CERTIFICATE OF APPROPRIATENESS

Property: 702 Sul Ross St, Tracts 3, 4, and 5, Block 11, Lockhart Connor and Barziza Subdivision. The property includes a historic 2,170 square foot, two-tory brick and wood frame single-family residence and a detached garage situated on an 8,925 square foot (75' x 119') corner lot.

Proposal: Alteration – Addition

ROOF PLAN

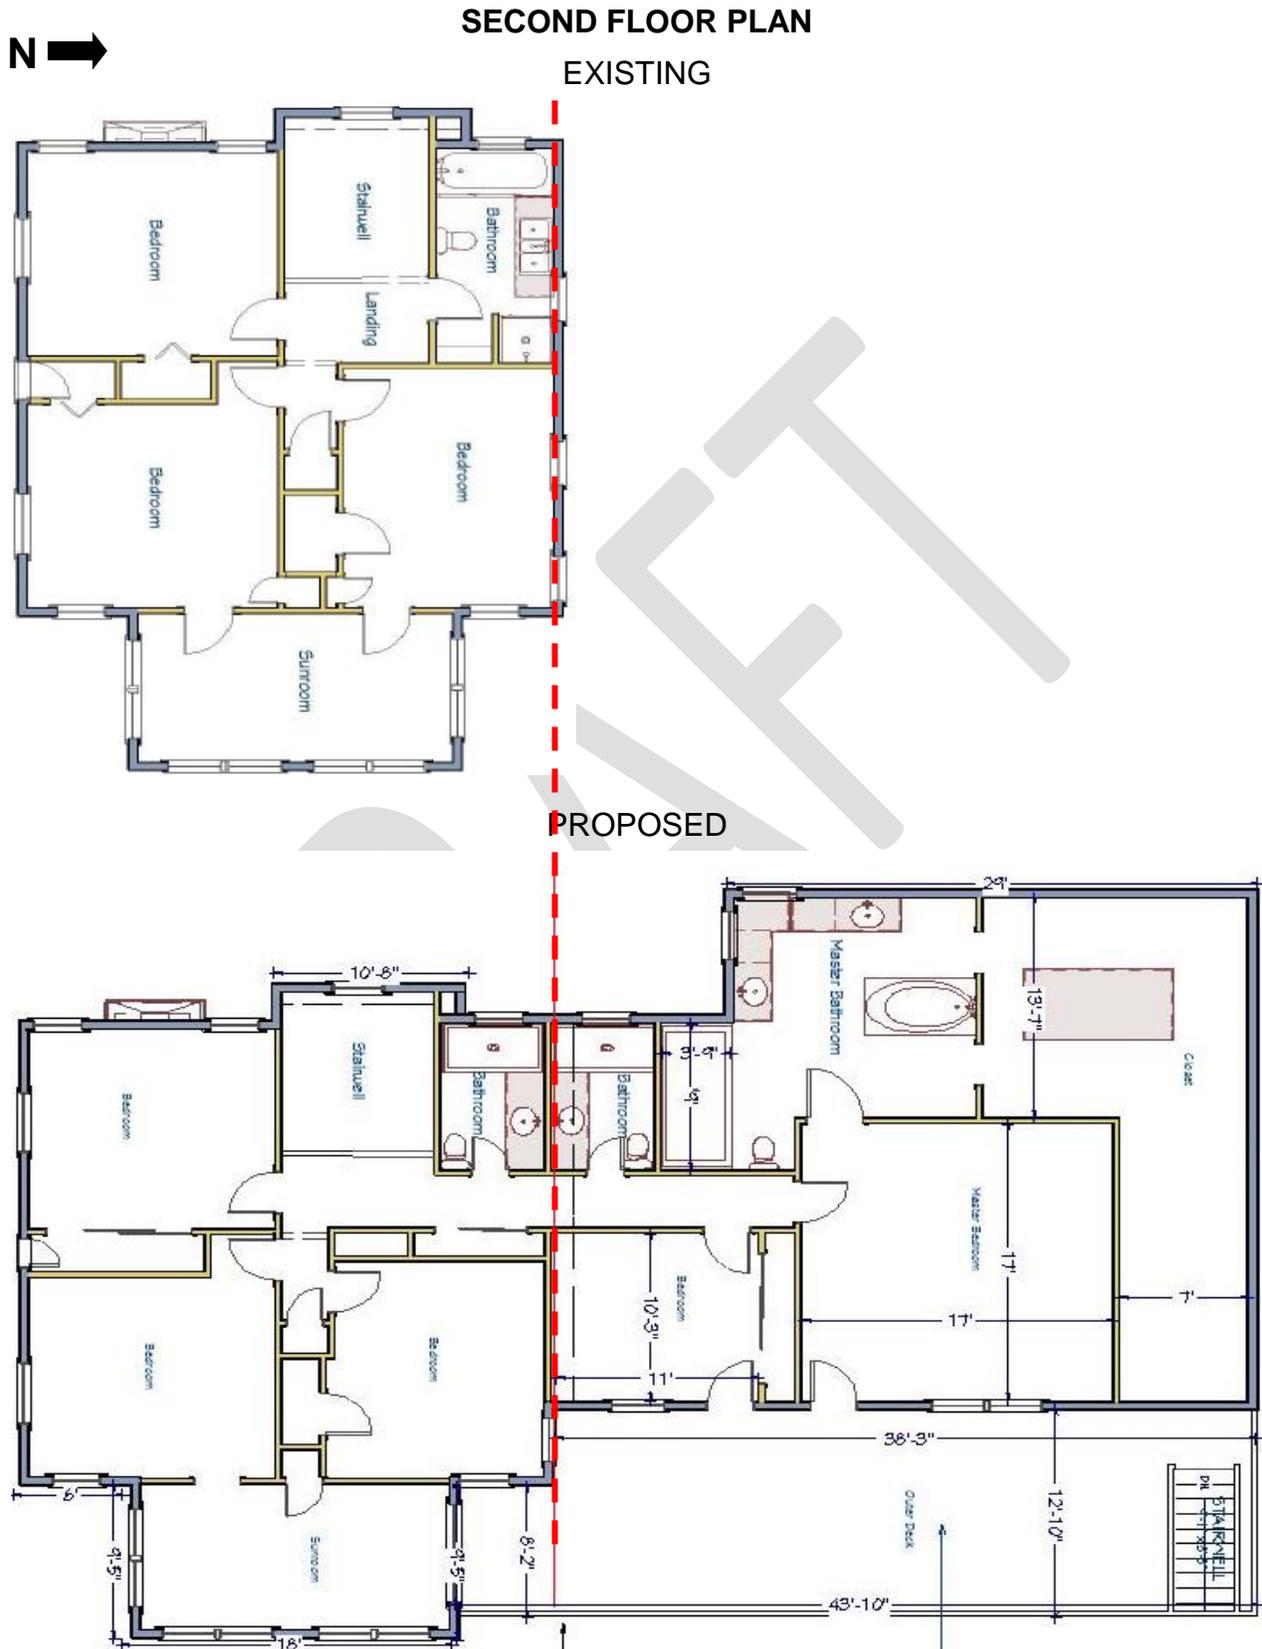
The proposed roof plan reflects a previously proposed alteration to the existing residence's hipped roof. The proposed alteration has since been removed from the scope of work. No alteration will be made to the form of the existing residence's roof.
